**ADDENDUM #2:**

**Invitation for Bid:** **ANIMAL RESOURCE CENTER REMODELING AND ADDITION PROJECT NO. PW20B035BLD**

**ADDENDUM NO. 2**

Architect's Addendum #2; Issued 26 May, 2020; (43) Items; (4) pages (4 attachments, 6 pp)

## DOOR HEAD—NEW WALL

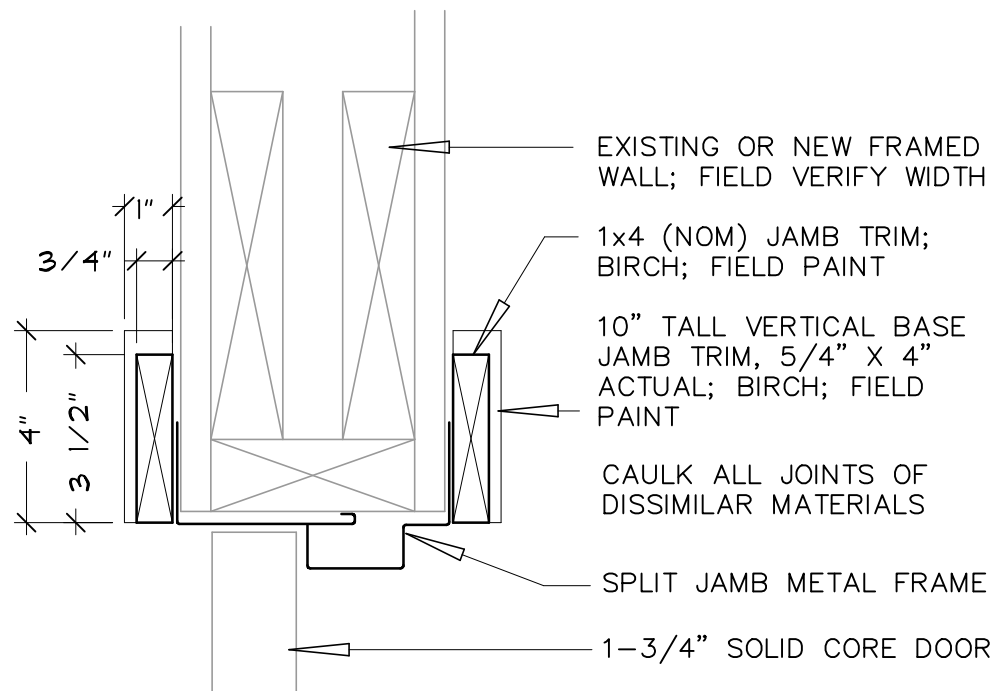
20. New/Modified Doors 22B, 46, 51, 52, 57A, 57B, 58B:
  1. Provide split jamb metal frames & Painted Wood trim both sides. See Attached Head & Jamb details 11 & 12 for trim configuration (matches existing door trim).

TITLE: **DIMENSION PRINT, KG80/100/125 6.2L ENCL.**

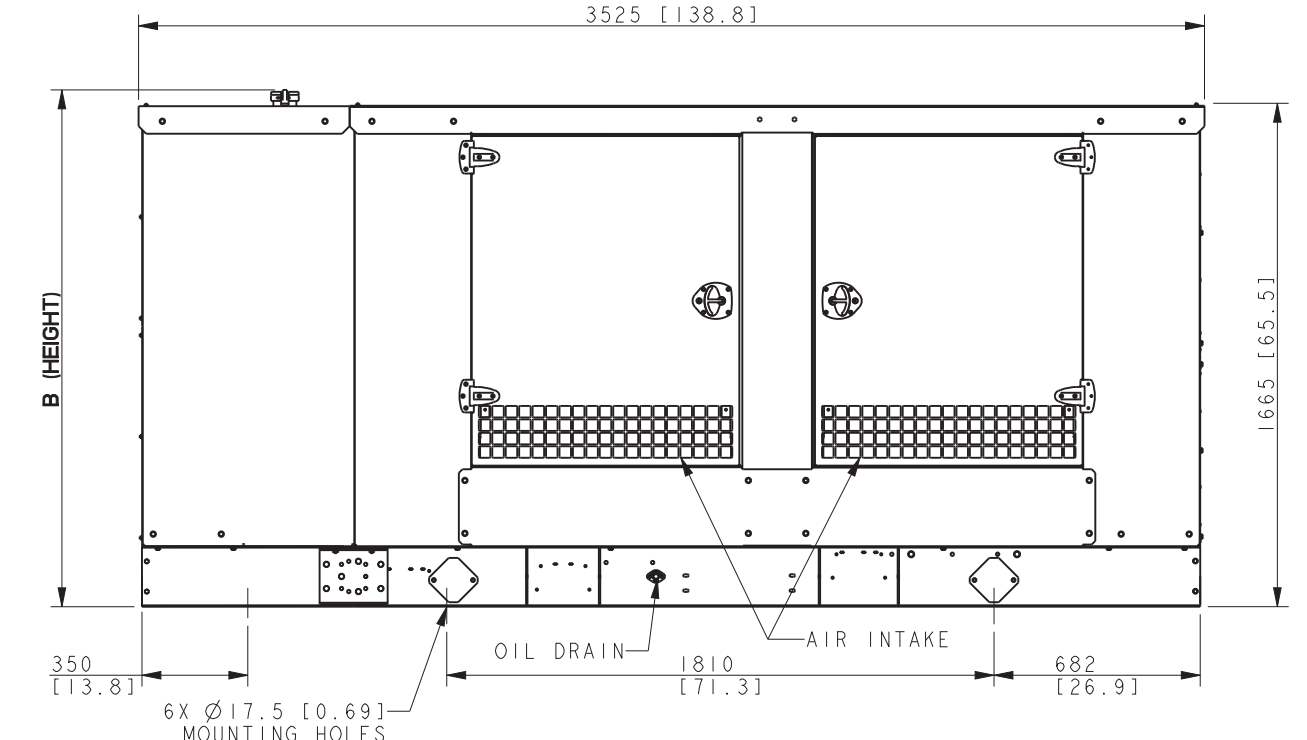
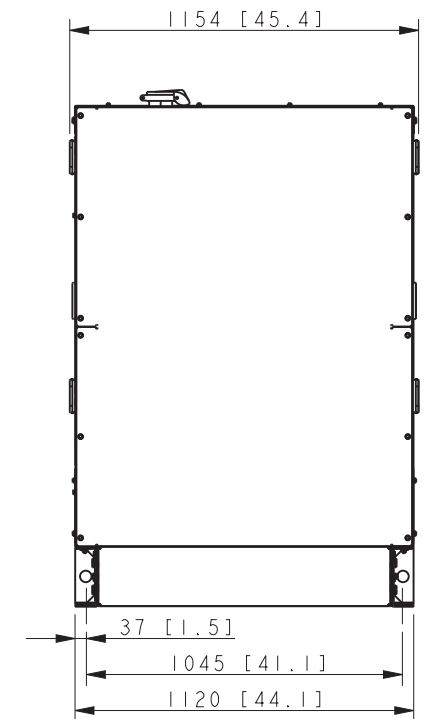
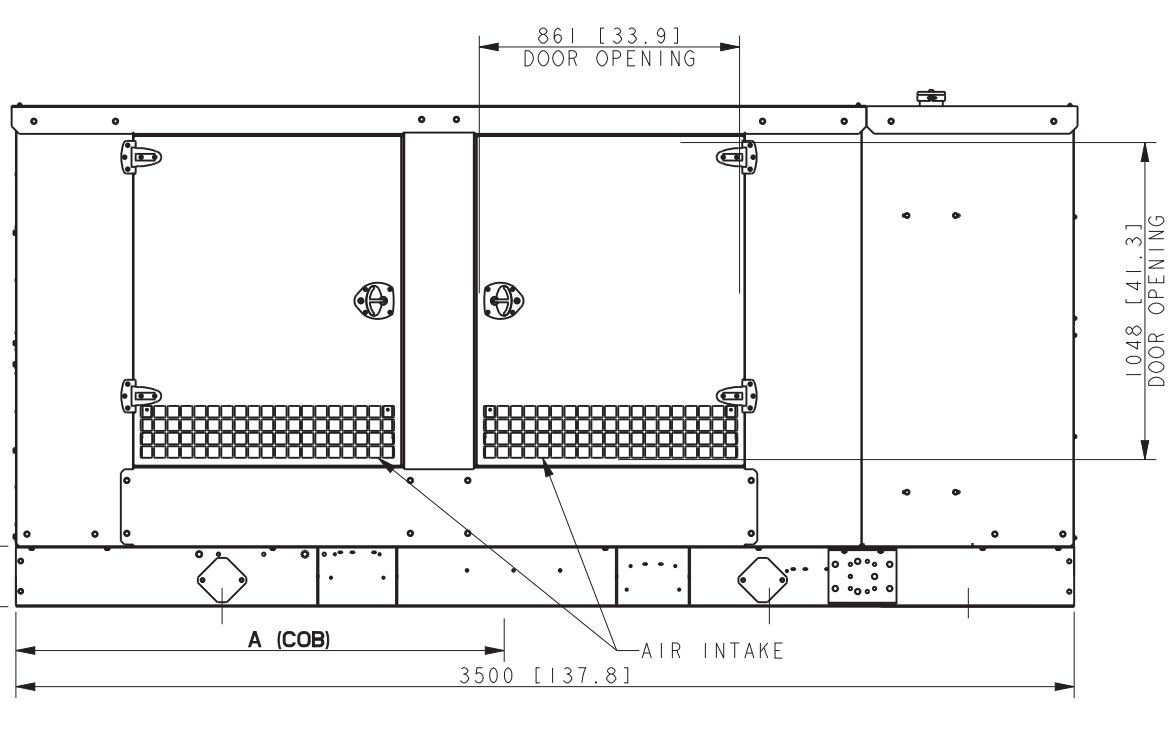
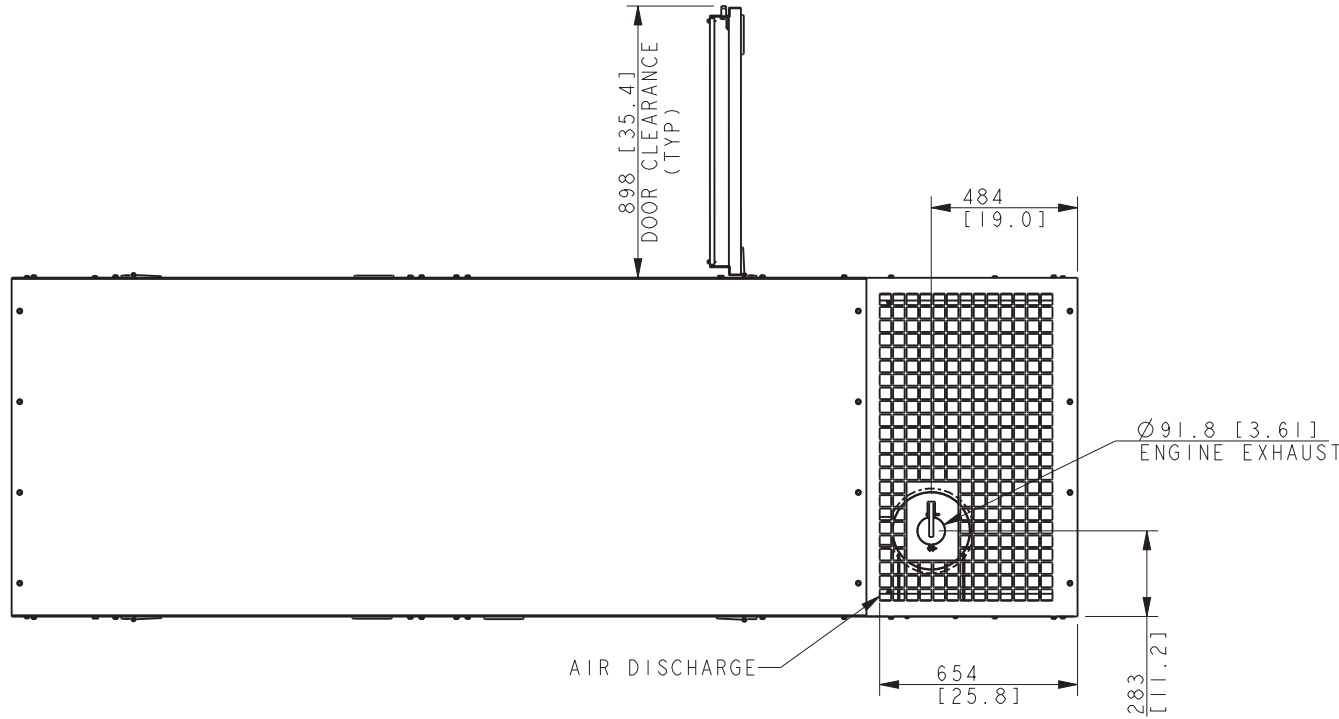
27. Generator:
  1. The generator fuel source is Propane Gas. No change to the propane system is required.
  2. Change Model to Kohler KG125 4R12X.
  3. Change Transfer Switch to 400A.
  4. See two attachments: revised Manufacturer's schematic (11x17") & Summary Sizing Report (8.5x11").
28. The 2-Bowl Scrub Sink, SK-1, shown in the Plumbing Fixture Schedule
  1. Getinge GSS102M; Manual operation (not electrical);
  2. With soap pump & dispenser
  3. Stainless Steel pedestal base
  4. Provide blocking in frame wall to support wall mounting of unit.
29. Interior Water Storage Tank (P1.3, Note 5) to be two hundred (200) gallon tank. Fixture Schedule and Schematic Elevation on P1.4 are in error.
30. Dog Grooming Sink P1.4 – This item is provided by the owner for install by the General Contractor. Hot & Cold water supply and a waste line are required.
